BID ADDENDUM NO. (1)

10/14/2025
South Seneca CSD
2022 Capital Improvement Phase II
2541.040

OVID JR/SR HIGH SCHOOL SED#: 56-05-01-04-0-001-025
INTERLAKEN ELEMENTARY SCHOOL SED#: 56-05-01-04-0-004-026

The following Addendum items shall be considered a part of the contract documents prepared by HUNT ENGINEERS, ARCHITECTS, LAND SURVEYORS & LANDSCAPE ARCHITECT, DPC.
Bid Document date of 10/03/2025

NEW FIELD ERECTED WASTEWATER PUMPING STATION (ALTERNATE #3)

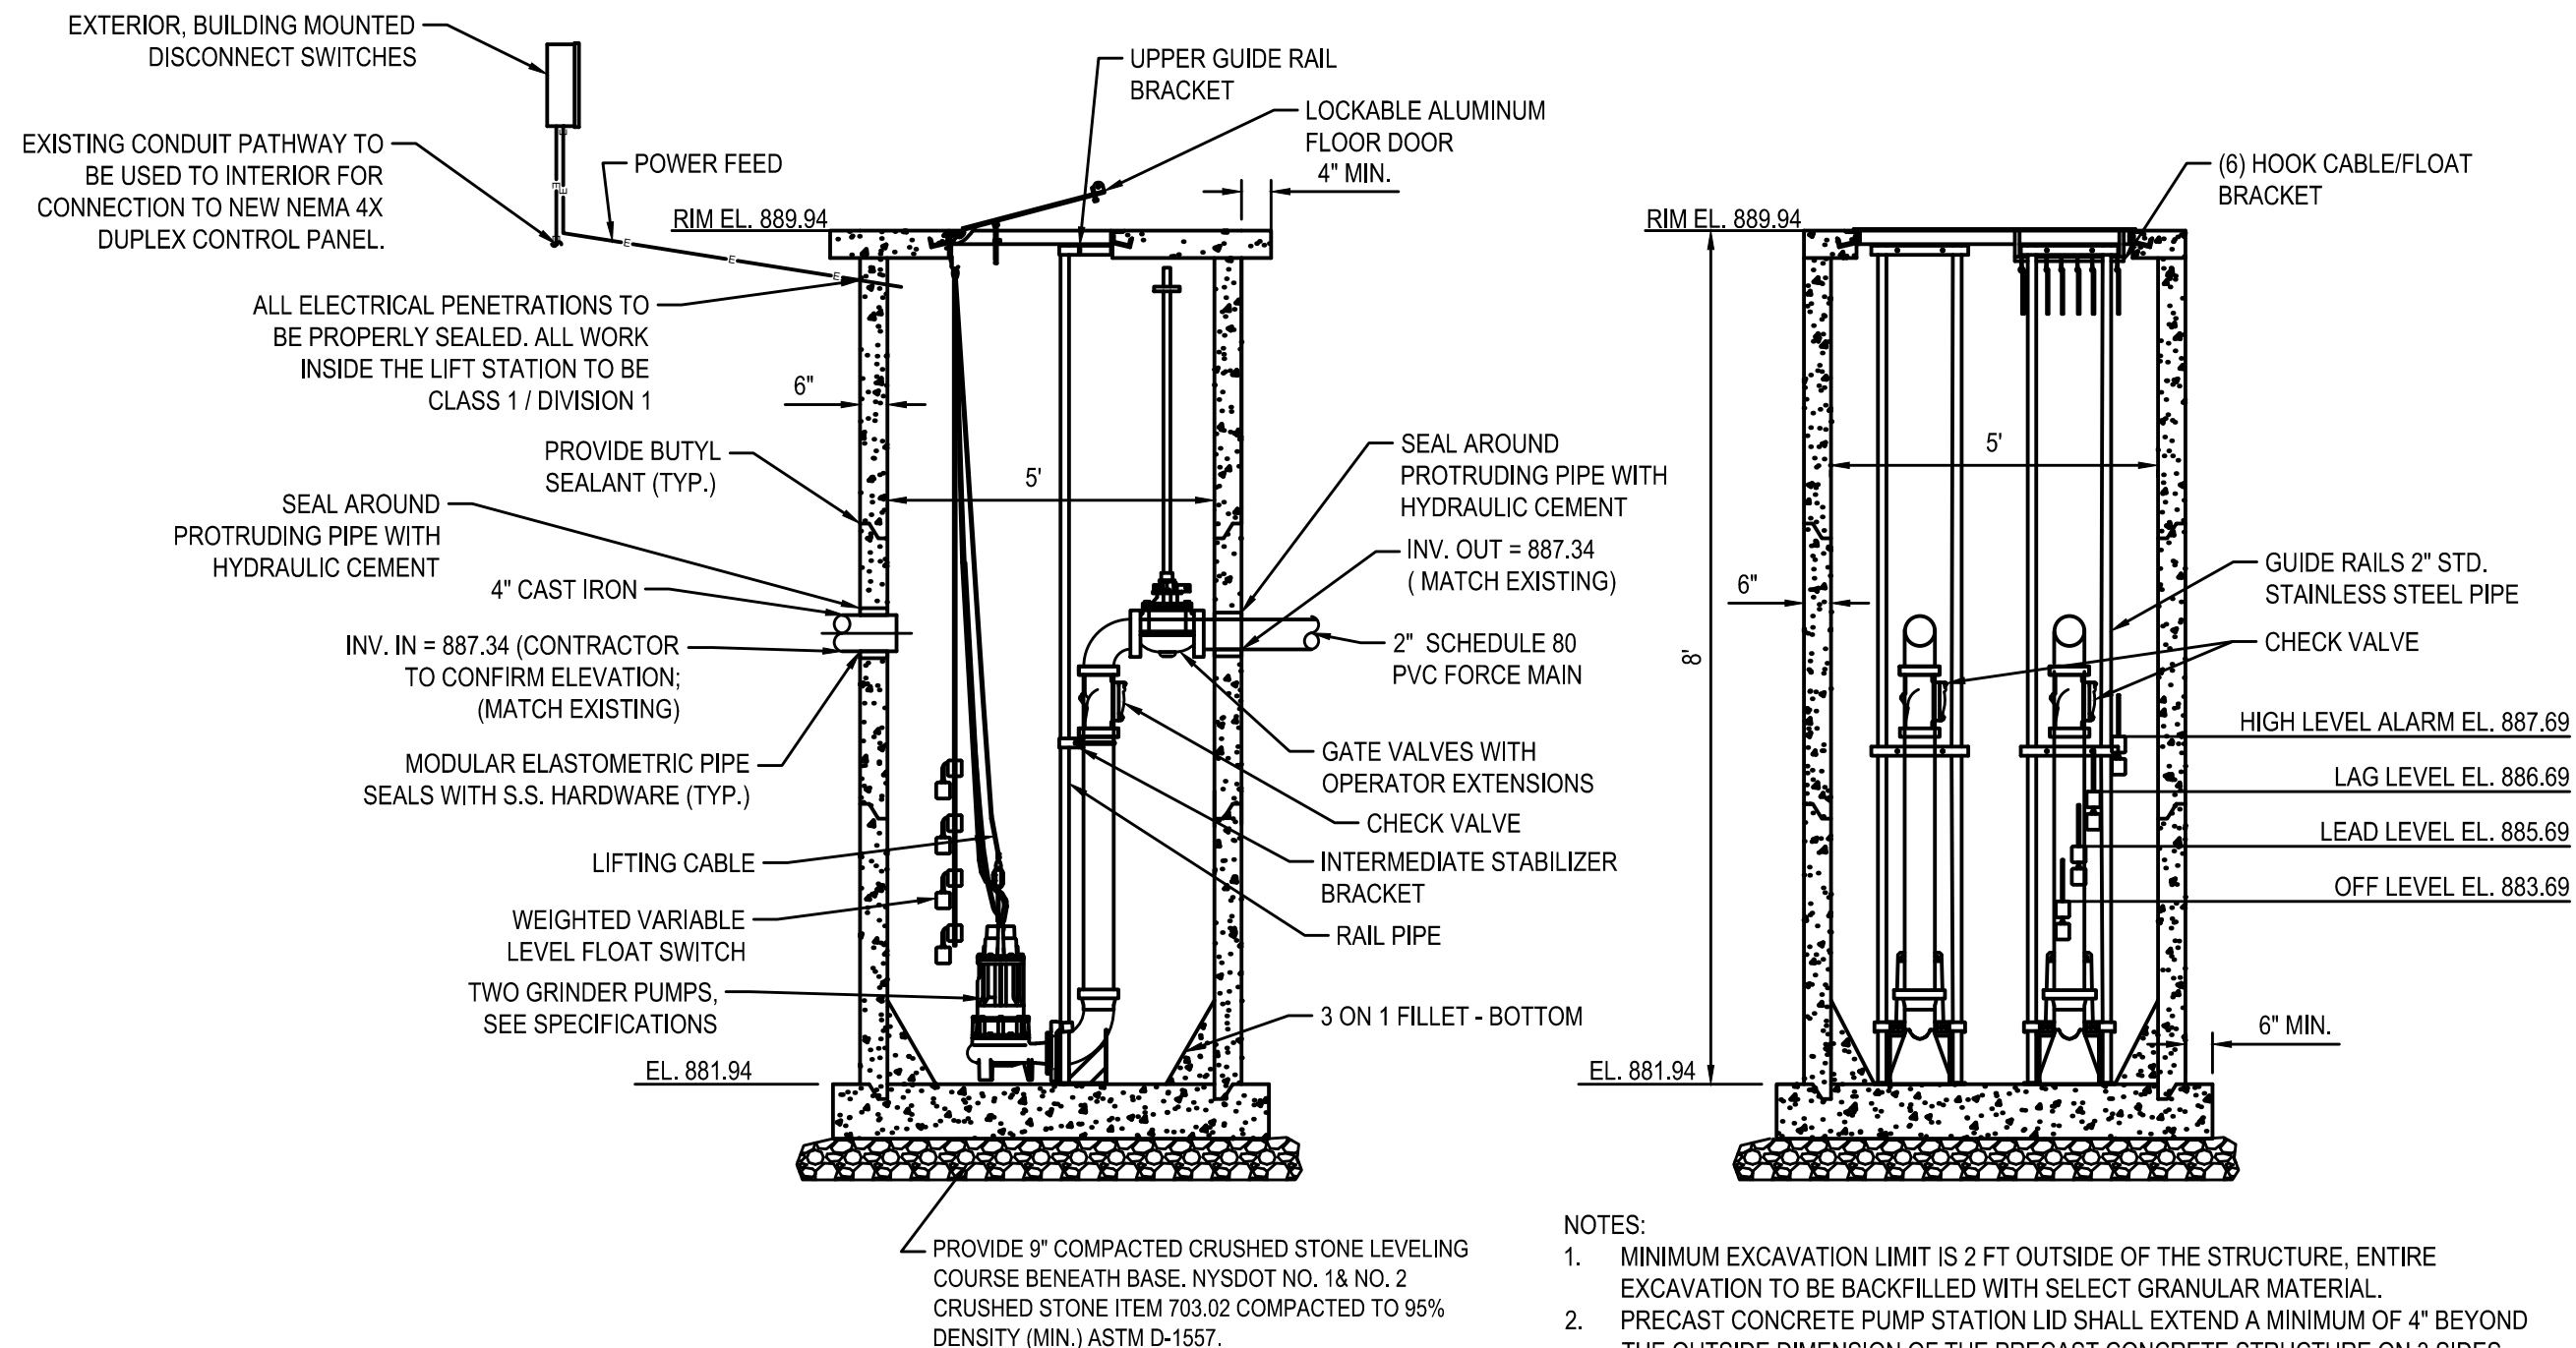
ITEM AD1-20 Refer to ES-L3.1 – SITE DETAILS

AMEND Site Detail 10 per AD1-L1 – WASTEWATER PUMPING STATION DETAIL UPDATES as issued by this addendum.

MECHANICAL PLANS FOR FIRST FLOOR
2022 CAPITAL IMPROVEMENT PROJECT PHASE 2
SOUTH SENECA CENTRAL SCHOOL DISTRICT
7263 MAIN ST., OVID, NY 14521

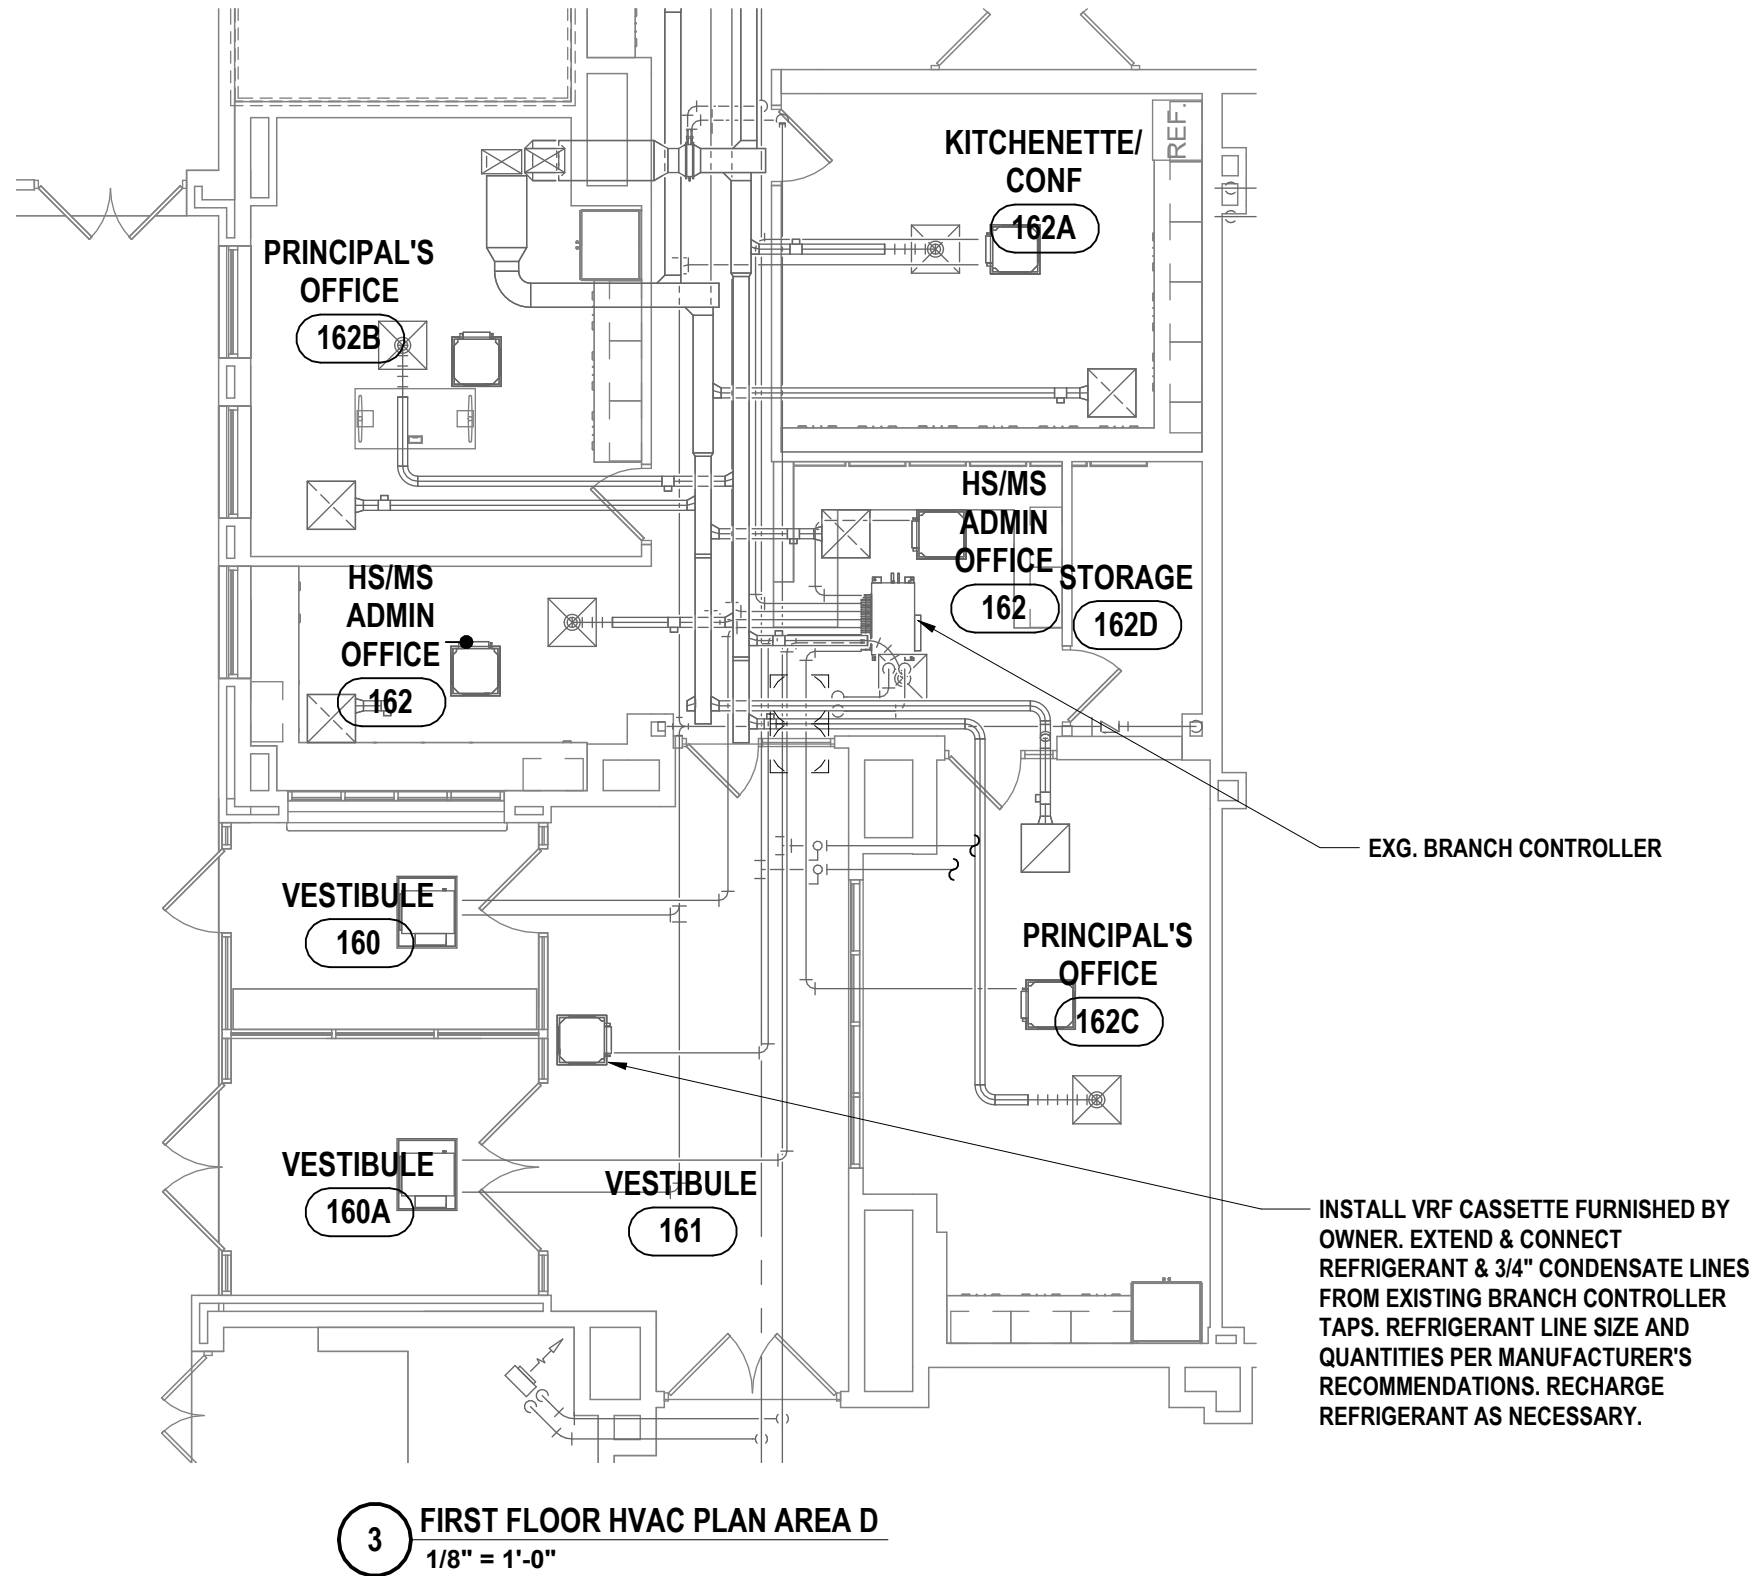
ITEM AD1-14 Refer to HS - H1.1 – FIRST FLOOR HVAC PLAN – AREA B

ADD View #3 as issued by this addendum on AD1-H1 – HVAC PLANS PARTIAL AREA D

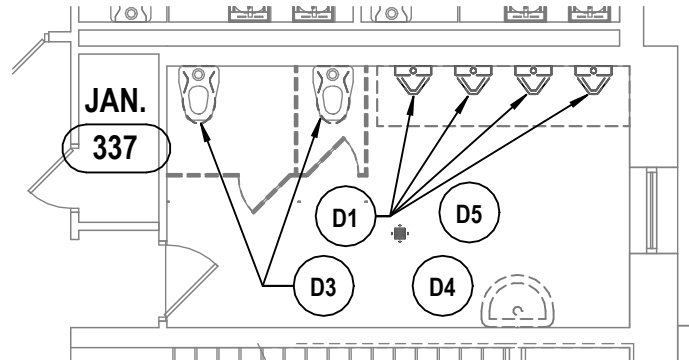
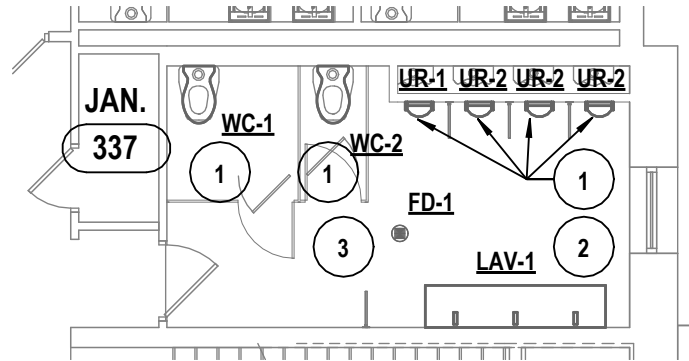
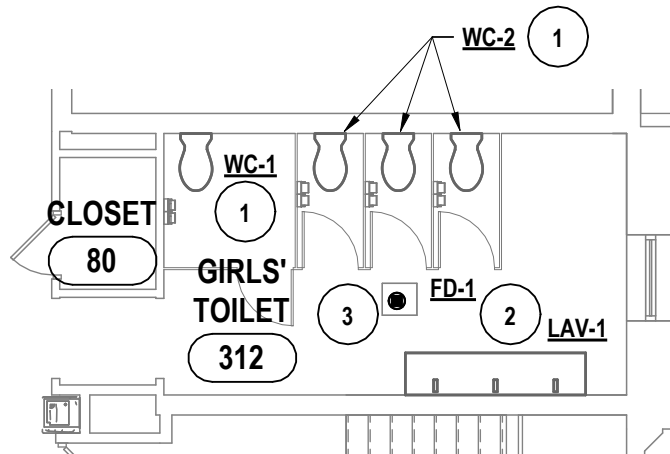
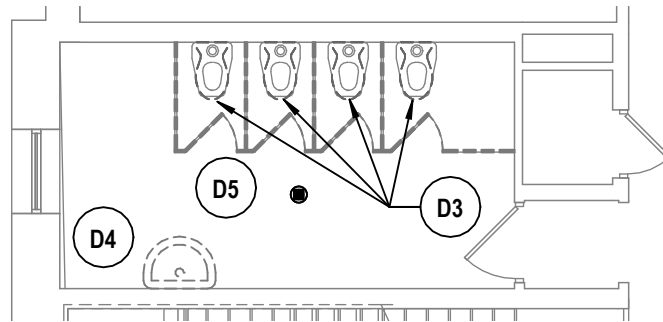
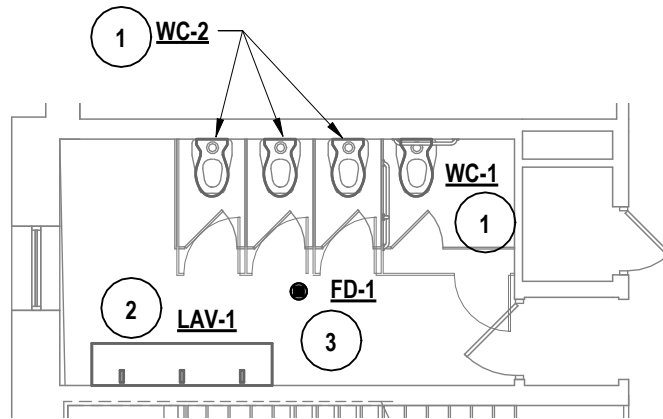
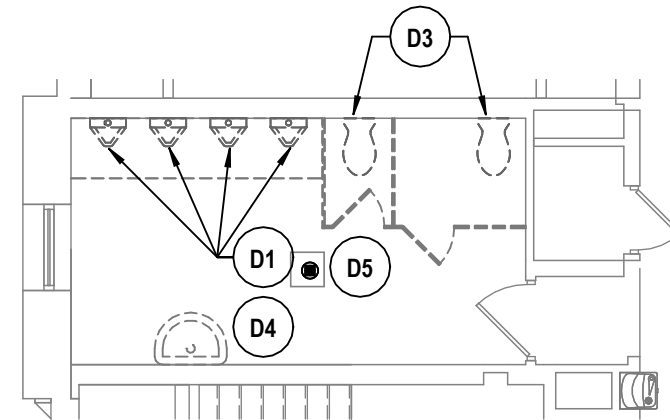
ITEM AD1-25 Refer to ES-P0.1 – PLUMBING DEMOLITION PLAN – AREA A & C

AMEND Detail 4, 5 and 6 per AD1-P1 as issued by this addendum.

ITEM AD1-29 Refer to ES-P1.1 – FIRST & SECOND FLOOR PLUMBING PLAN – AREA A
AMEND Detail 3, 4, 5, and 6 per AD1-P1 as issued by this addendum.
